RE: IDNR Permit C20220006
USACOE LRC-2021-454

From: Laurie Morse
To: Casey, James; Soren.G.Hall@usace.army.mil
Subject: [External] [BULK] Message from the Winnetka Village President: Statement on Elder-Centennial Beach
Date: Friday, June 3, 2022 12:28:16 PM

From:	Steve Huels
To:	Casey, James
Subject:	[External] Comment: Shore Protection/Public Beach Project, in Lake Michigan, at Elder and Centennial Parks, in Winnetka IL
Date:	Wednesday, June 1, 2022 5:07:54 PM
Attachments:	IDNR Letter Orchard 2020.docx

View facing south

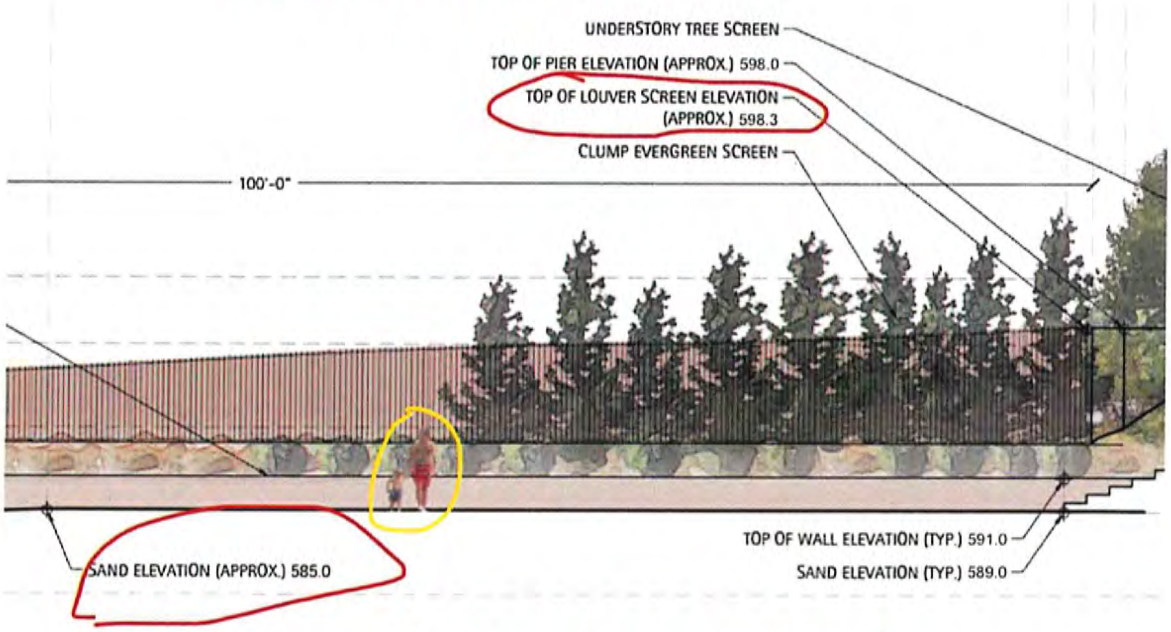
We see no reason why we can't have the same type of breakwater as Lloyd. It would preserve the continuous shoreline view, access and be a far more natural landscape.

Top of wall is 13 feet
above sand level

View facing south

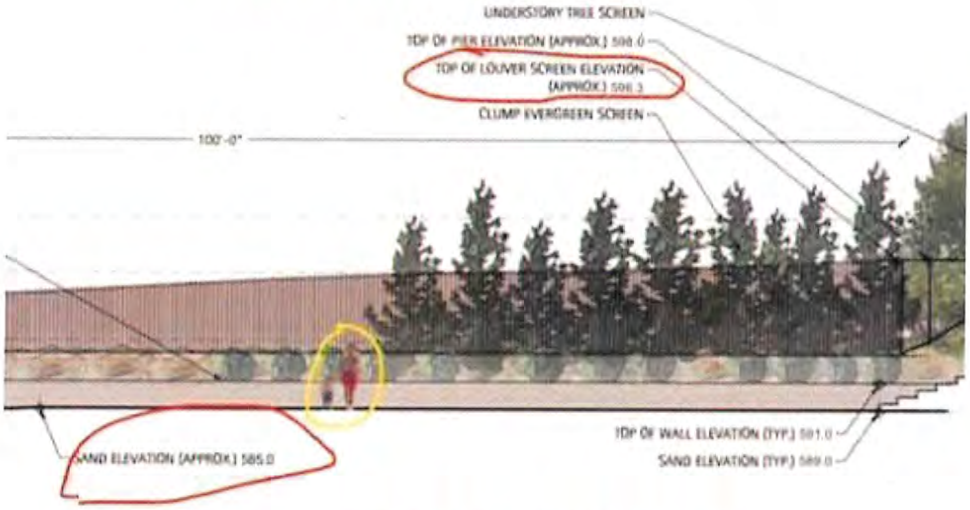
Top of wall is 13 feet
above sand level

To my knowledge the proposed "Steel louvered air screen", which would extend from the base of the bluff to the shoreline, was not part of the original 2030 plan for the combined Elder + Centennial Beach, nor has it ever been used on any other beaches on the North Shore. It is unproven, and if this element of the plan is approved, could set a dangerous precedent for other Public Beaches to become walled in. I believe such a move is in violation of the Illinois Public Trust Doctrine. Frankly, the walled in aspect of the design appears to benefit the adjacent private land owners, at the expense of the tax paying village residents who want to enjoy a Public Park, and its prime location on a beautiful Public Beach.

ELDER/CENTENNIAL BREAKWATER SCREEN

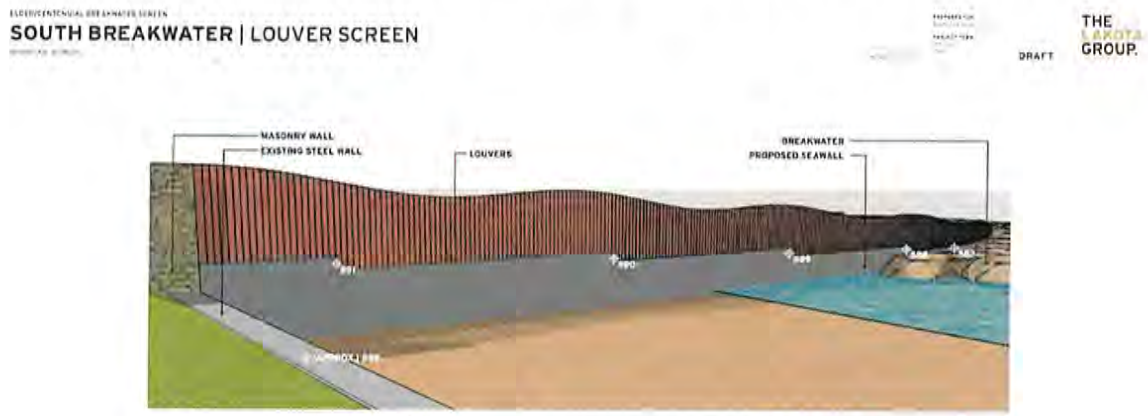
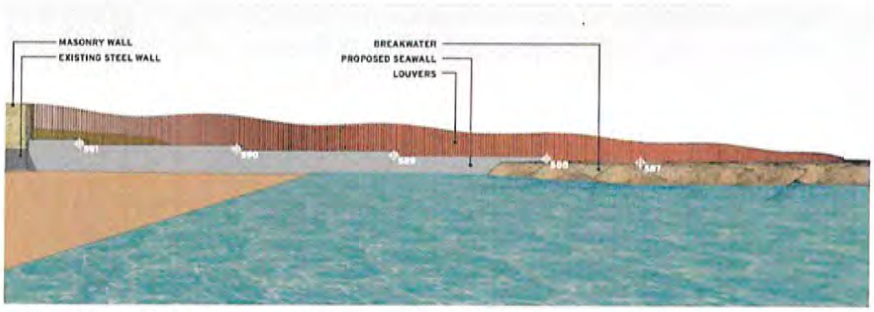
4. Shoreline erosion protection and bluff preservation can be accomplished without the downsides of the current design. Also, the applicants did not offer less restrictive alternatives to this beach in a cage concept.

In case you have not seen the design, here are two renderings from the consultant working on the project. I hope you will agree that this project has no place on our public beaches.

SOUTH BREAKWATER | LOUVER SCREEN
DRAFT
THE LAKOTA GROUP.

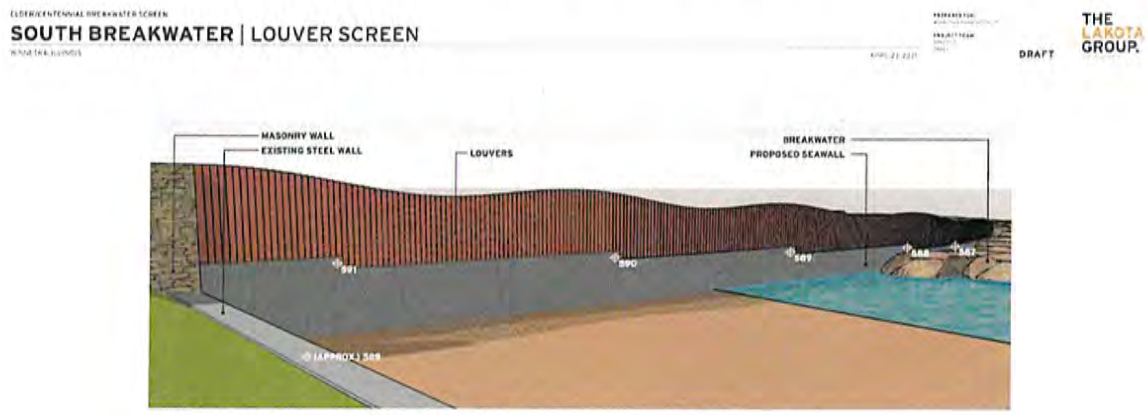
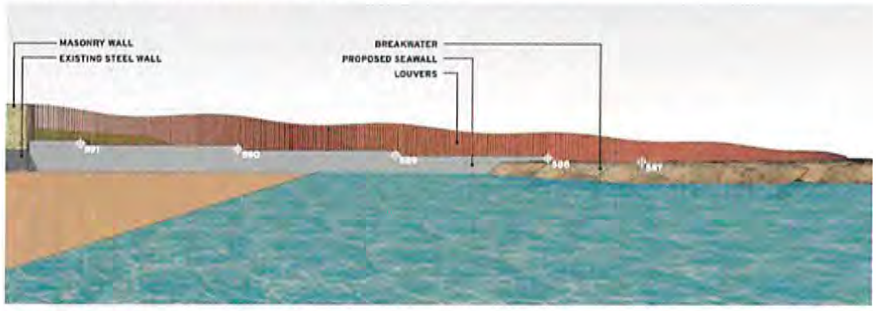
4. Shoreline erosion protection and bluff preservation can be accomplished without the downsides of the current design. Also, the applicants did not offer less restrictive alternatives to this beach in a cage concept.

In case you have not seen the design, here are two renderings from the consultant working on the project. I hope you will agree that this project has no place on our public beaches.

ELDER/CENTENNIAL BREAKWATER SCREEN

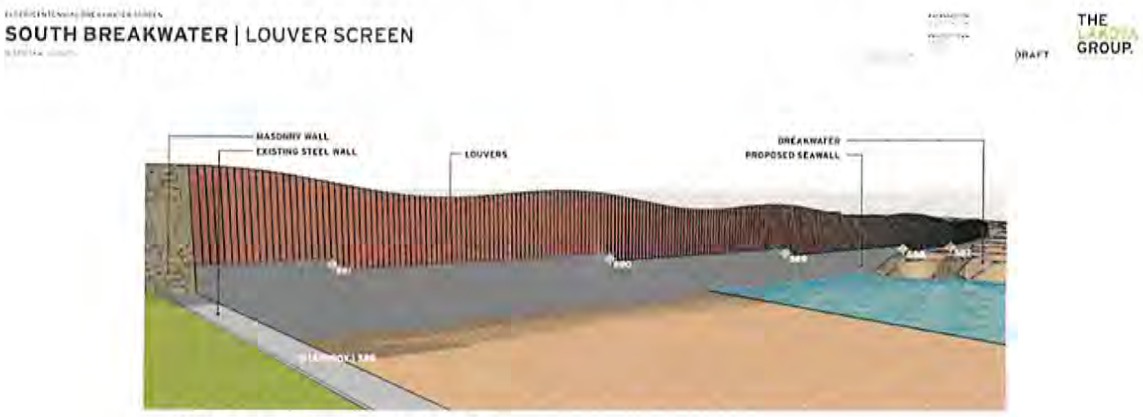
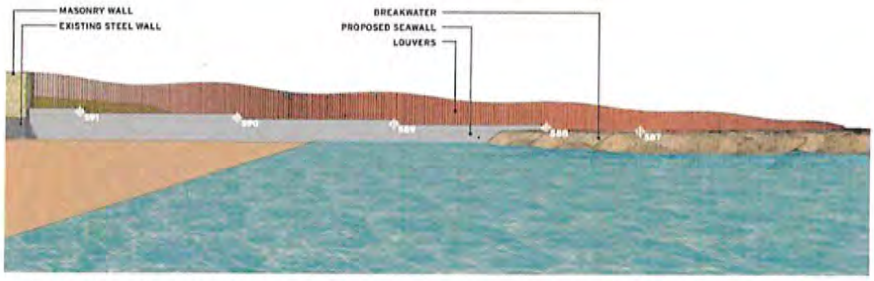
4. Shoreline erosion protection and bluff preservation can be accomplished without the downsides of the current design. Also, the applicants did not offer less restrictive alternatives to this beach in a cage concept.

In case you have not seen the design, here are two renderings from the consultant working on the project. I hope you will agree that this project has no place on our public beaches.

Shabica figures 4 and 7 annotated to show heights relative to a 6 foot high stick figure.

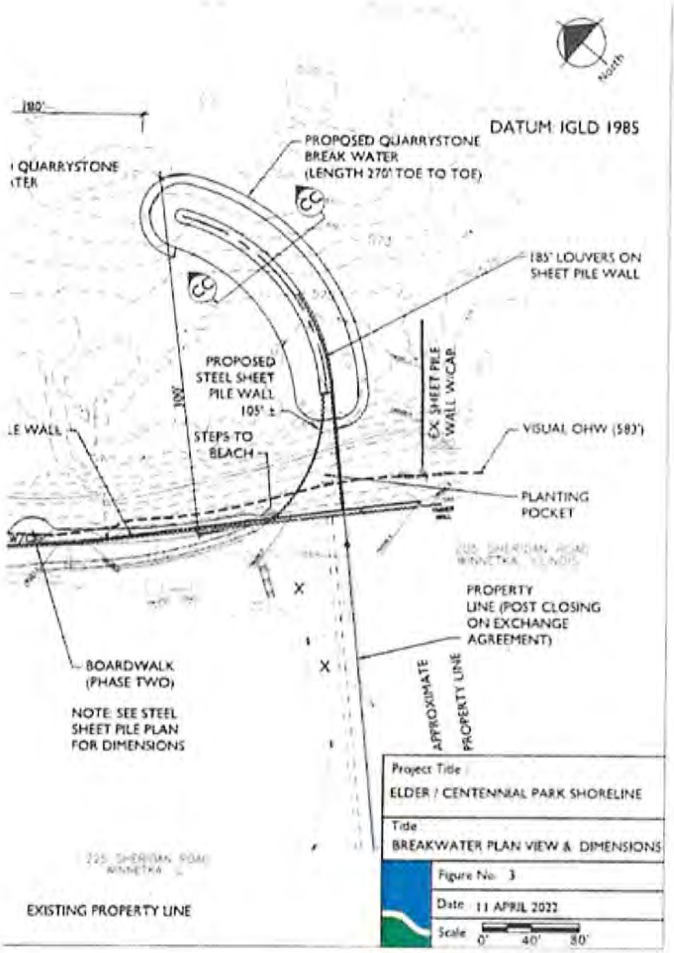
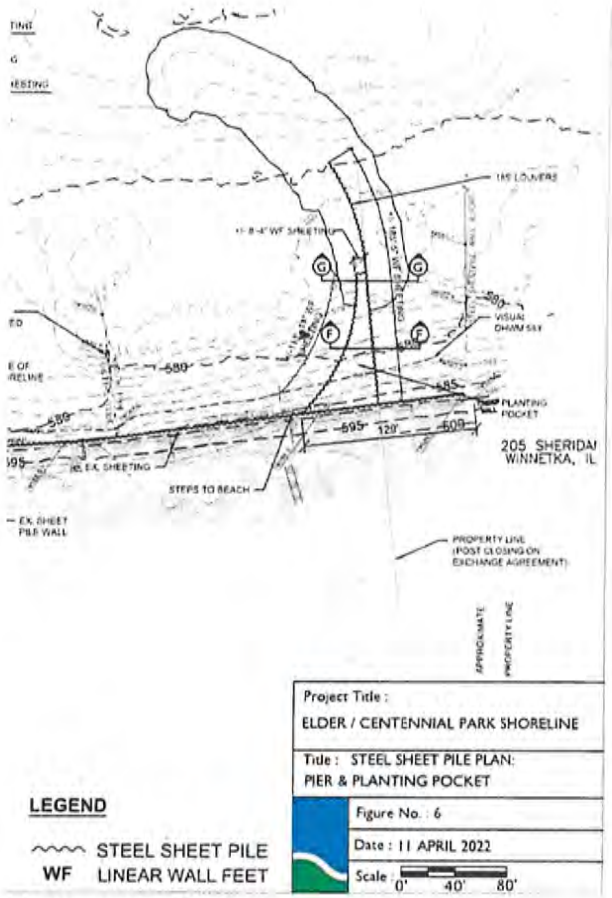
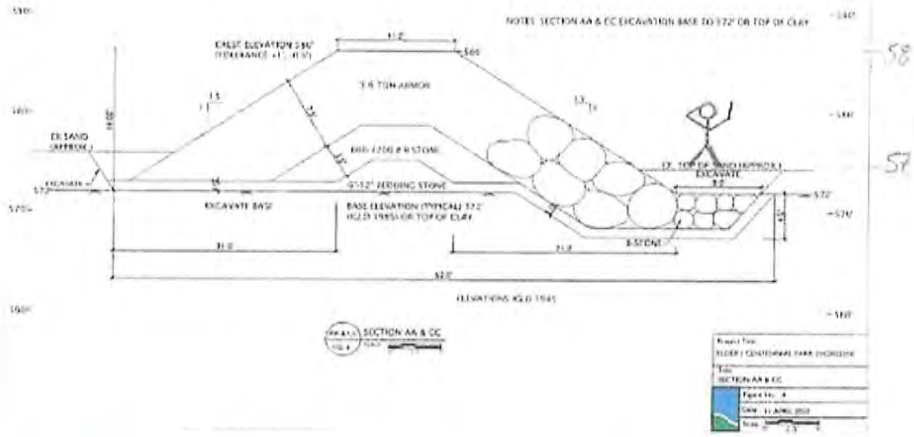
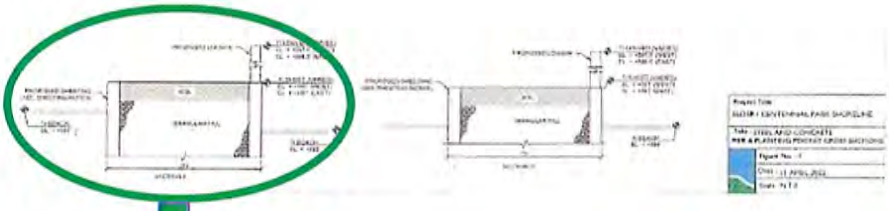
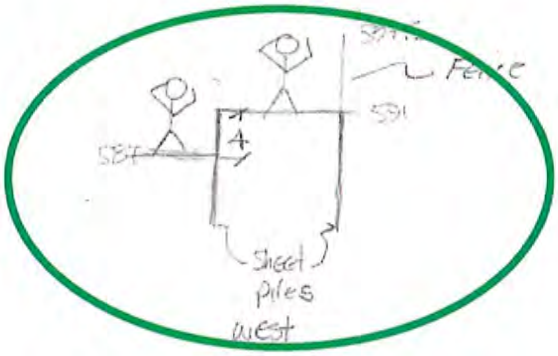
1) If the breakwater is built as shown – without specifically designed
   - access stairs over the boulder rip rap in cross section CC shown in Shabica Figures 3 and 4 below on page 4 or/and
   - passage over planter pocket, and through lovers shown in cross sections FF and GG in Shabica Figures 6 and 7 below on page 5 with annotations

a. No cross section similar to CC of the breakwater is provided that contains a stairway design.
      i. Why is such a detailed design not required?
      ii. This breakwater essentially is a 4.5 foot high rubble stone wall at OHWM of 581.5 and 11 feet high at lake elevation of 575 shown on Shabica Figure 4 and that blocks beach access as shown on the attached cross section CC annotated with the addition of a 6 foot high person for scale.

ii. This planter pocket is essentially is a 4 foot high rubble stone wall at beach elevation 587 as drawn in Shabica Figure 7. A Shabica Figure 7 cross section FF (with appropriate heights) is annotated with the addition of a 6 foot high person for scale.

c. No cross section similar to FF and GG of the louver fence is provided that contains an opening for lateral beach access.
   i. Why is such a detailed design not required?
   ii. This louver/fence is essentially another 6.5 foot high barrier at beach elevation 587 as drawn in Shabica Figure 7. A Shabica Figure 7 cross section FF is annotated with the addition of a 6 foot high person for scale.

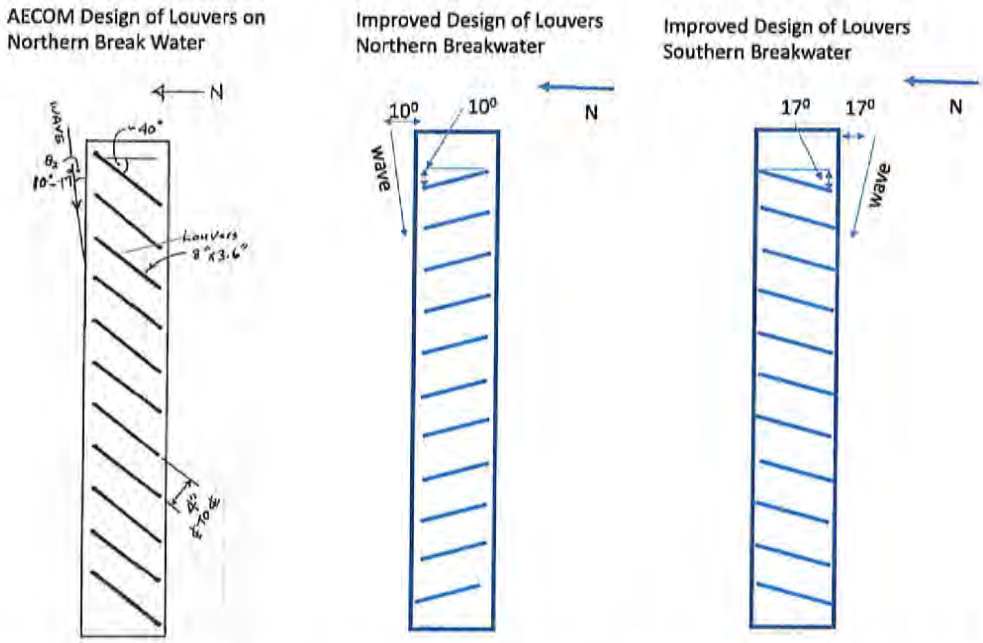
According to Aecom the northern breakwater structure has a 91% reduction of overtopping with 82% of this reduction due to the stone breakwater and 9% due to the louvers and the southern breakwater structure has a 96% reduction of overtopping with 92% of this reduction due to the stone breakwater and 4% due to the louvers. Aecom fails to state how reduction of overtopping correlates quantitively to reduction of wave energy and beach and bluff erosion. However, if Aecom is correct in claiming reduction of overtopping is a measure of effectiveness of the stone-louvered breakwater, then their table above shows that the impact on reduction of wave energy by the louvers alone in the northern breakwater is small and reduction on the southern breakwater is even smaller. These minimal benefits from the louvers do not justify the loss of the lake's panoramic view or loss of public access to public beaches north and south of the parks.

The louvers in the design are poorly positioned to absorb wave energy or prevent overtopping. The louvers are supposed to be positioned for waves attacking from the north-northeast on the northern breakwater and from the southeast on the southern breakwater. The attacking waves strike the louvers at an oblique angle allowing much of the wave energy and overtopping to pass through the louvers. In the drawing below I show an alternate design for the position of the louvers where the attacking waves strike the louvers at a ninety-degree angle.

In this design waves are reflected back into the lake away from the shore and overtopping is reduced as a result of more effectively blocking of the wave's path. The alternate design also allows the public a better view of the shoreline. As mentioned above the louvers in the Aecom design contribute little to prevention of beach and bluff erosion; however, if the IDNR permits this design it should require that the louvers be positioned in a manner that optimizes the reduction of wave energy and overtopping.
